Sub-Committee of Experts on the Transport of Dangerous Goods

Electric storage systems

Comments on document ST/SG/AC.10/C.3/2010/81

Transmitted by the experts from P. R. China

Attachment 1: pictures for samples with diameter of 14mm

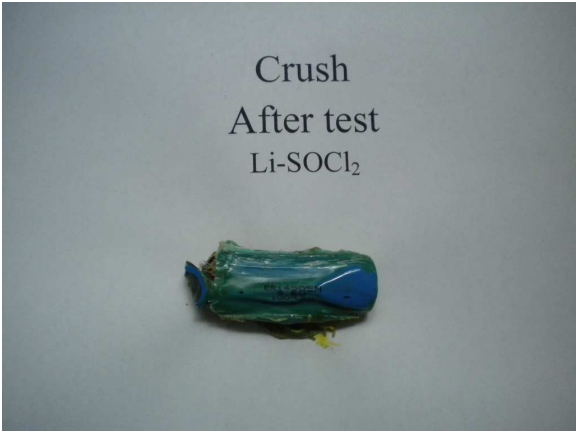
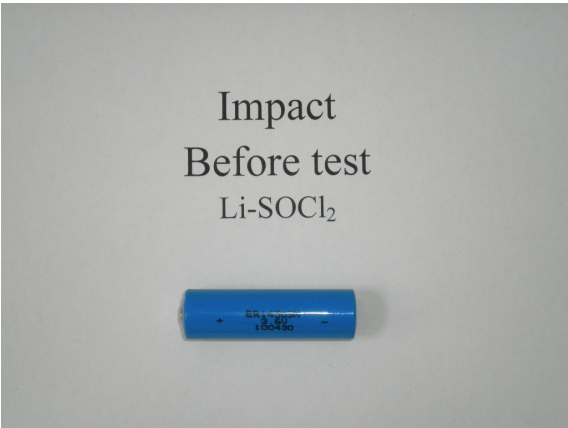
5. To appraise the two kinds of tests on cylindrical cells further, we choose a cylindrical lithium cell with a diameter of 14mm to conduct both impact and crush test. After impact, it caught heavy fire and failed the test. Then we run the crush test on it. There is no fire and no temperature rise (see attachment 1 for pictures and attachment 2 for videos). Again we could see the impact is more effective on this kind of cylindrical cell.

6. According to the test results, we do not support adoption the text on diameter scope (great than 20 mm for cylindrical cells in impact test and not more than 20 mm for cylindrical cells in crush test) in ST/SG/AC.10/C.3/2010/81.

7. We suggest the sub-committee to consider the proposal for scope of T6 test as below:
Impact (applicable to cylindrical cells)
Crush (applicable to prismatic, pouch, coin/ button cells).
